**REQUEST FOR WAIVER FROM ACCESSIBILITY REQUIREMENTS
OF CHAPTER 553, PART V, FLORIDA STATUTES**

Name: A.M.E. Research Building

Address: 2003 Levy Avenue, Florida State University, Tallahassee, FL 32310

The A.M.E. Research Building is a 2 story, 60,337 GSF, institutional building on the Florida
State University Campus. It is a laboratory and research building which also provides office
space for administration and faculty.

ENLARGED SEMINAR ROOM PLAN

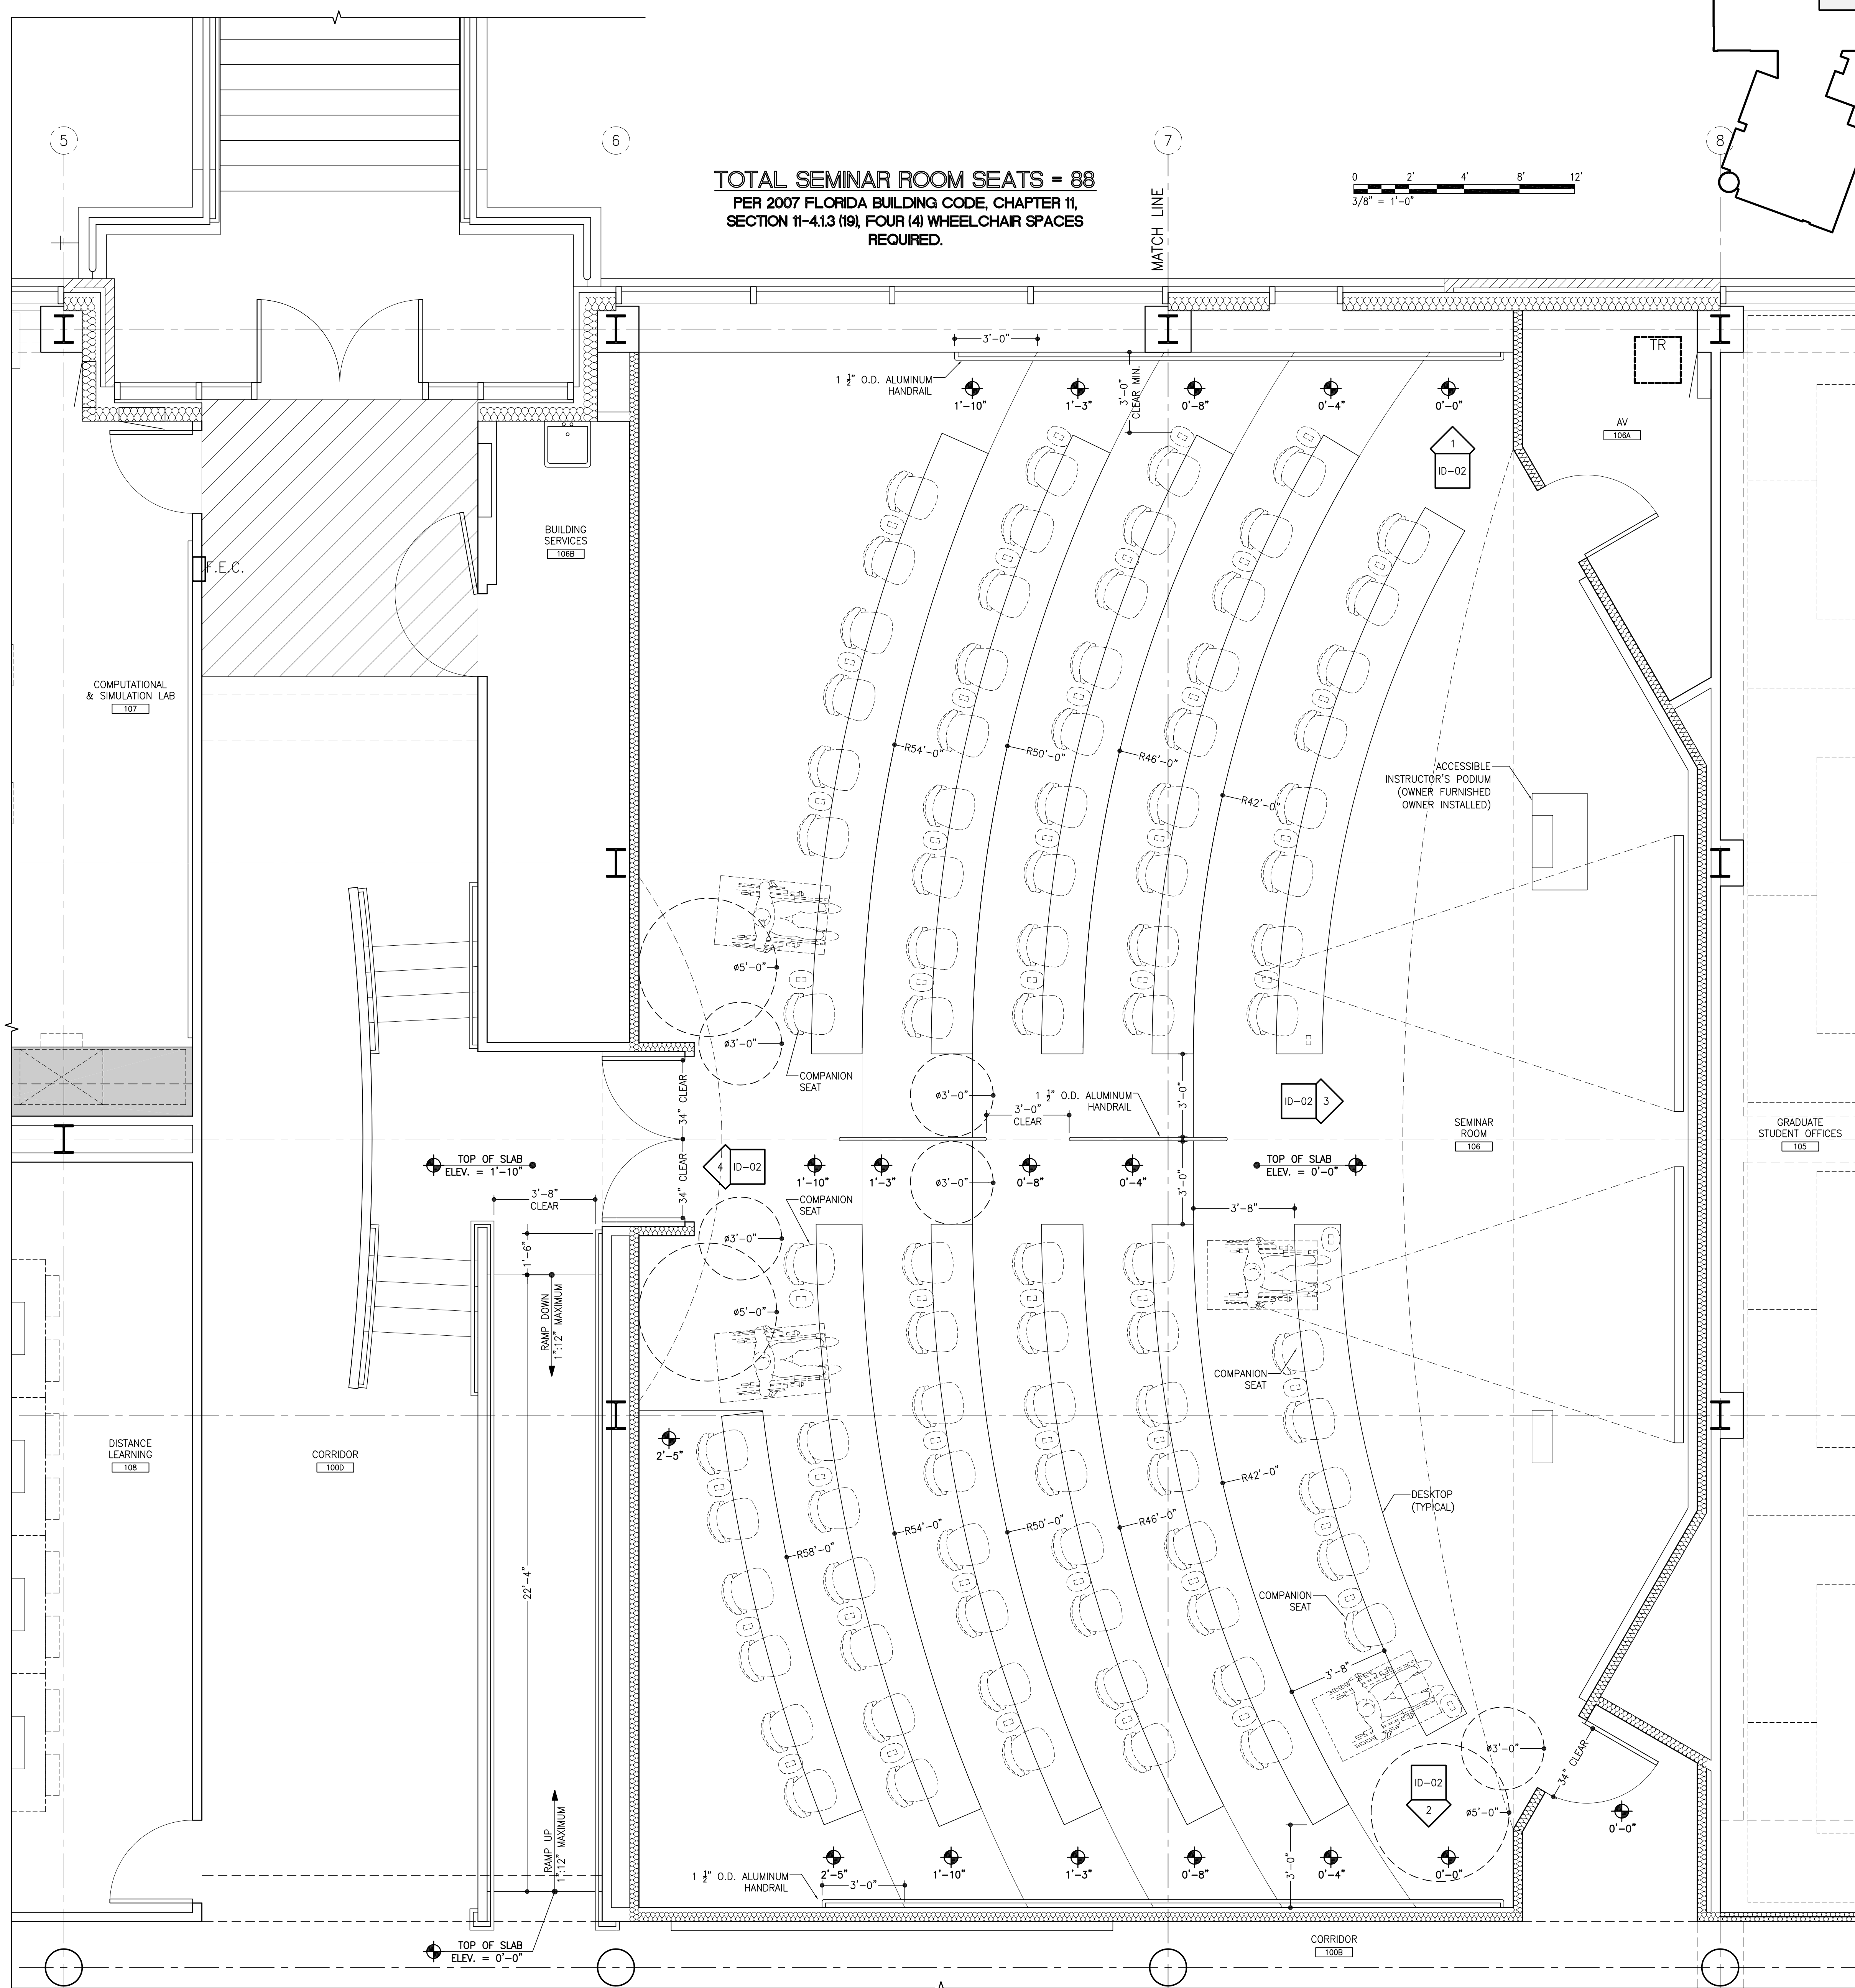
At Seminar Room 106, the tiered floor slab provides an optimal line of sight throughout the space. Although this condition does not allow for the equally dispersed spaces required by 11-4.33.3. We propose to provide a total of four (4) wheelchair spaces with two (2) equally distributed in the rear row near the main entrance and two (2) located near an entry door at the front row.

To provide access to all tiers of the seminar room would greatly reduce the number of seats and distort the optimal view created. We are able to create accessible spaces with companion seats adjacent to accessible routes. Therefore we believe the requirement for further dispersal should be waived.

The waiver for this seminar room is being requested because the quality of the performance of the space is in question. Every effort has been made to provide accessible spaces and routes at both the front and back of the auditorium without interfering with other remaining seating. Through this design, the line of sight, acoustics, and accessibility have all been maintained and not compromised.

Comments/Recommendation Approve Request
